Millstone Power Station Unit 2, Response to Request for Additional Information Regarding Generic Letter 2004-02.

**MILLSTONE POWER STATION UNIT 2**  
**RESPONSE TO REQUEST FOR ADDITIONAL INFORMATION REGARDING**  
**GENERIC LETTER 2004-02**

**DOMINION NUCLEAR CONNECTICUT, INC.**  
**MILLSTONE POWER STATION UNIT 2**

**Figure 1: Debris Bed after the Test M2-C1**

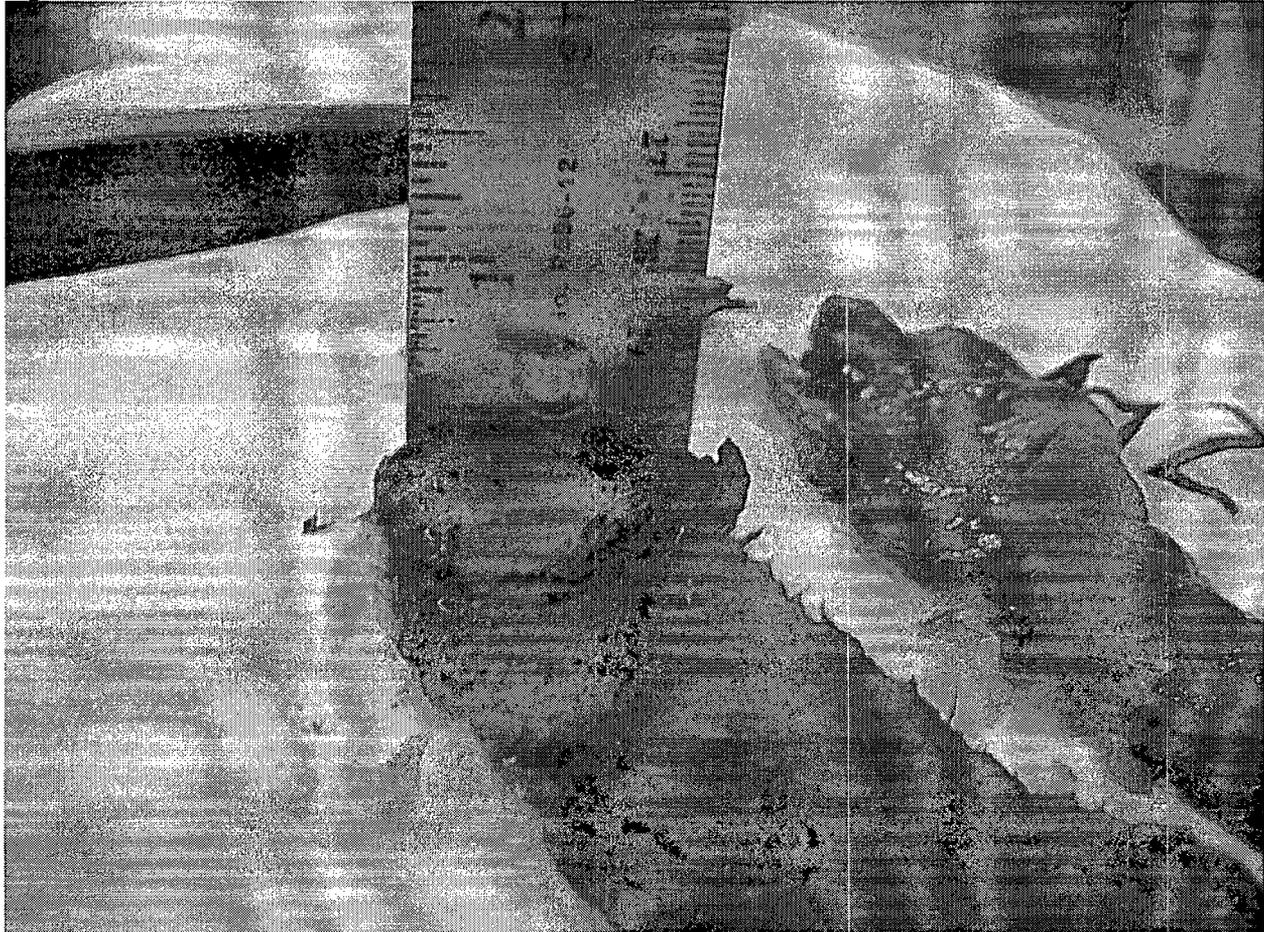
*This RAI identified some differences in non-chemical head losses between the two test facilities. The December 18, 2008, DNC letter provided the first docketed information providing significant information on the MPS2 Rig-89 testing. The NRC staff has reviewed this and determined that the following information is needed to complete the review:*

- a. *Please provide information that justifies that the Rig-89 head loss test was conducted with a fibrous debris load that maximized non-chemical debris head loss.*
- b. *Please provide information regarding whether the debris bed contained adequate fiber to ensure that a maximum head loss was attained without bed disturbances limiting the head loss.*

Figure 1 shows the debris bed after the test. It can be seen that a uniform debris bed was formed across the whole surface of the test strainer. Figure 2 shows a portion of the debris bed removed from the strainer surface after the test.

Figure 1 and Figure 2 also show the debris bed was firm and uniform across the entire surface of the fin with no crack or hole or other degradations; also the final thickness of the bed was measured to be nearly  $\frac{1}{4}$  inch, which was more than the theoretical thin bed thickness. The fully developed thin-bed thickness thus ensured debris bed structural integrity for the subsequent chemical additions.

**Figure 3: Calcium Release Data from MPS2 pH 7 and pH 8 Dissolution Tests without Tri-Sodium Phosphate at 90°C**

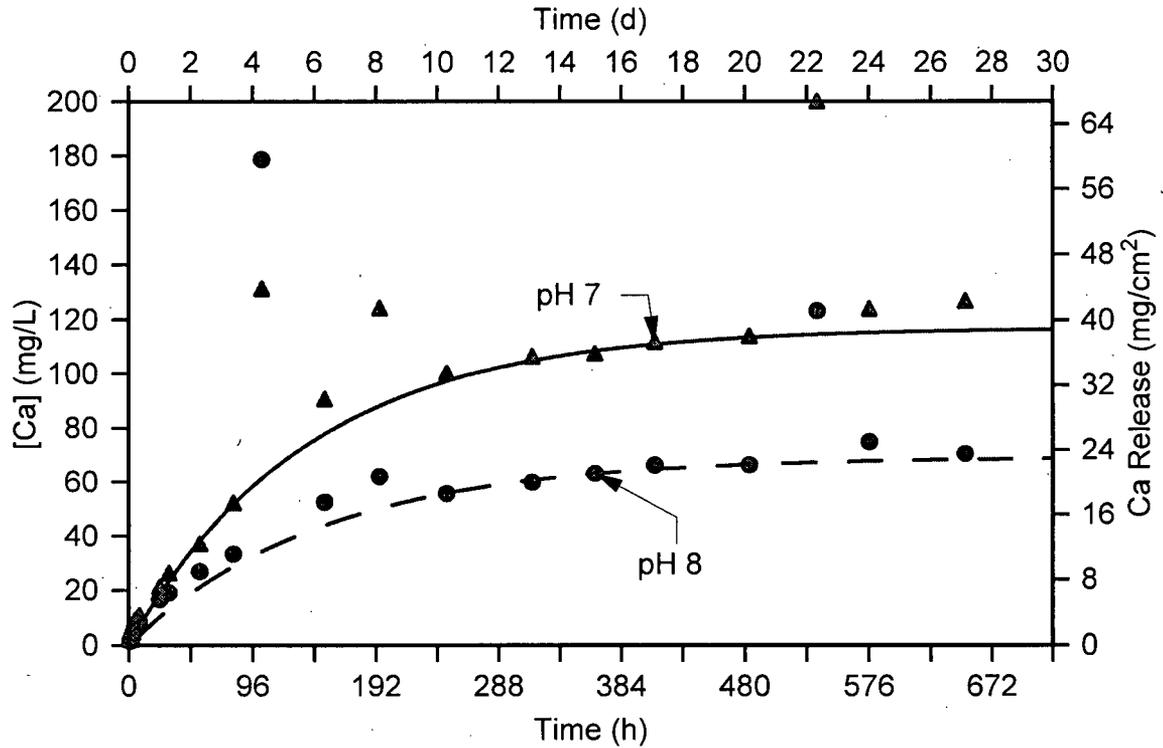
*12. The MPS2 calcium dissolution test at a pH of 7.0 resulted in a 30-day calcium concentration of 126 mg/L. DNC's December 18, 2008, letter states that the pH 7.0 case (without tri-sodium phosphate present) was used to determine the concentration of calcium in the Rig-89 test. However, the calcium concentration used for Rig-89 testing was 40.4 mg/L. Please justify why 40.4 mg/L is a representative value in the Rig-89 testing when the dissolution testing conducted with scaled quantities of concrete resulted in a calcium concentration of 126 mg/L.*

Because the concrete SA/V ratio for containment differs from that tested, the results obtained are non-representative but may be appropriately scaled. Normalization of the dissolution test data may be performed by dividing the results (in mg/L) by the SA/V ratio (3.0 cm<sup>2</sup>/L), as indicated by the right-hand vertical axis in Figure 3. Similarly, the fit to the calcium concentration data, described below, may also be normalized to produce a calcium release equation. Thus, the 30-day calcium release per unit area of concrete can be read from the figure or calculated from the fit and used to calculate the calcium release from a known surface area of concrete.

Figure 3 also shows first-order curve fits to the data represented by Equations 1 and 2. These were determined using robust fitting procedures within TableCurve 2D<sup>†</sup> that reduce the fitting errors caused by data outliers. The constants found within Equation 1 were reported in Table 2-5 of the bench-top Test Report [7] and Table O-2 of DNC's December 18, 2008 letter. Equation 2 may be calculated from Equation 1 by dividing the initial constant by the tested surface area-to-volume ratio, 3.0 cm<sup>2</sup>/L.

**Figure 5: Calcium Release Data from MPS2 pH 7 and pH 8 Dissolution Tests (without TSP)**

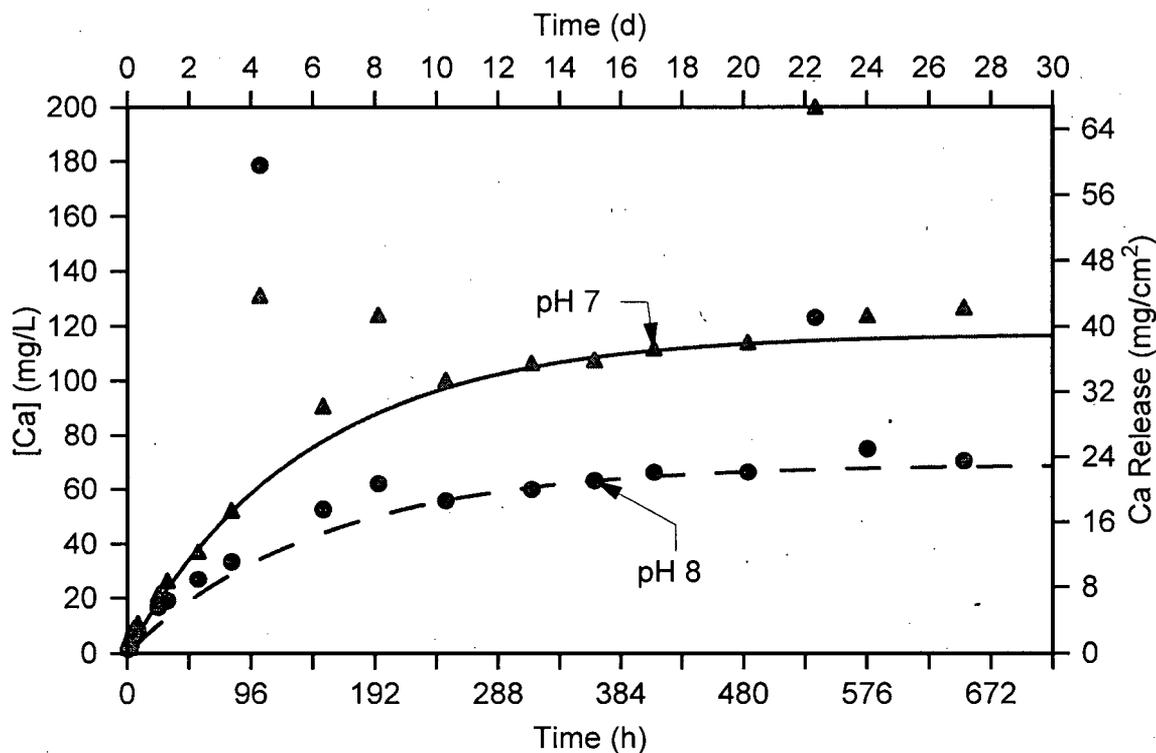
*13. In Attachment 1, Table 0-2, of DNC's December 18, 2008, letter, the calcium concentration for time infinity is shown as 117 mg/L for pH 7.0. Please explain why this concentration for time infinity is appropriate, given the 30-day bench test calcium concentration at pH 7.0 was 126 mg/L.*

As with any datum, the measured calcium concentration for the day 30 sample was subject to sampling and statistical errors, with the magnitude of the statistical error alone being about  $\pm 8$  mg/L. When the data are evaluated as a whole, the data fit produced by TableCurve 2D calculated a calcium concentration of 117 mg/L for time infinity; it should be noted that this value is arguably identical to 126 mg/L within the experimental error. Sources of error are further discussed below.

It is immediately apparent that the data contain a few outliers. It is important to consider that each datum suffers to some degree from experimental errors (position in the solution at which the tube was placed, contamination of sample vials, insufficient filtering of samples before analysis, pH drift, etc.). For example, if the sample had been taken from a location in the flask near a source of calcium (concrete or fibrous debris), the result could have been biased high. There is also uncertainty (statistical error) associated with the analysis technique, ICP-OES; this uncertainty was approximately  $\pm 8$  mg/L for the 117 mg/L measurement. Therefore, considering all sources of error and uncertainty, there is no statistically significant difference between 117 mg/L and 126 mg/L.

Figure 6: 3D Illustration of the WCAP Aluminum Release Model

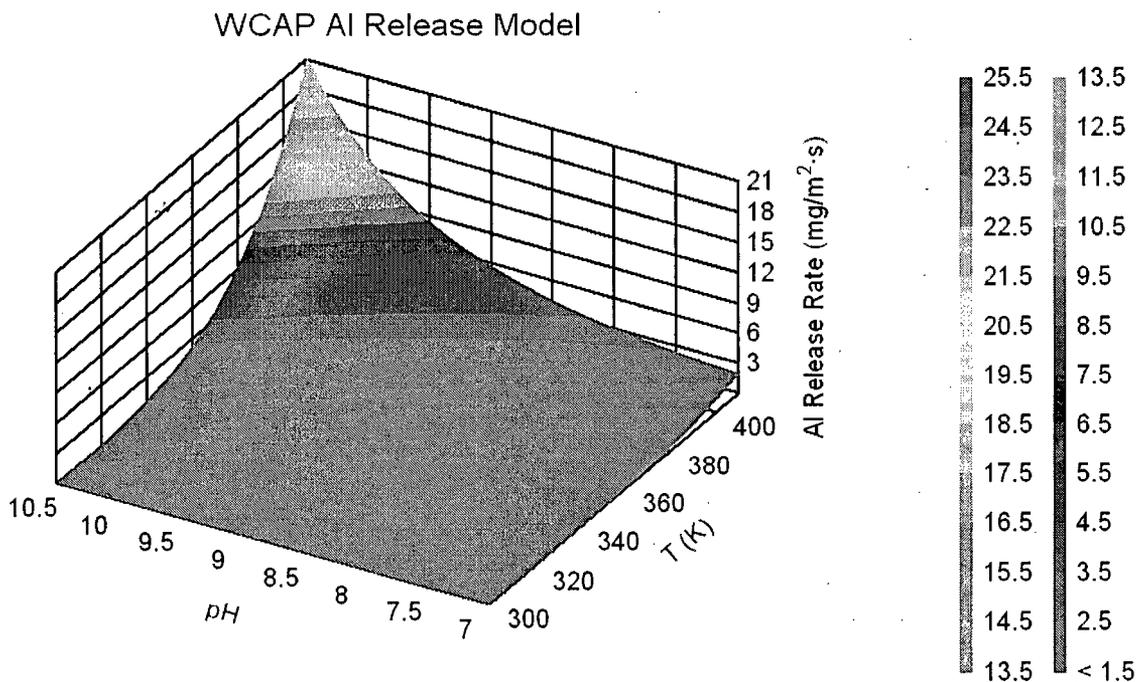
*15. Please compare the total amount of aluminum that is predicted to be released by the AECL model with that predicted by the WCAP-16530 base model (i.e., no refinements for silicate or phosphate inhibition). Discuss any significant differences between the plant specific predictions for the two methods, including the acceptability of these differences.*

The WCAP-16530 base model is an empirical model of the aluminum release rate (RR) based on the data set described by Lane et al. [8], which included data from ICET 1, CR-6873, WCAP-7153A and WCAP-16530. The WCAP model is described by Equation 3 and the results are shown in Figure 6.
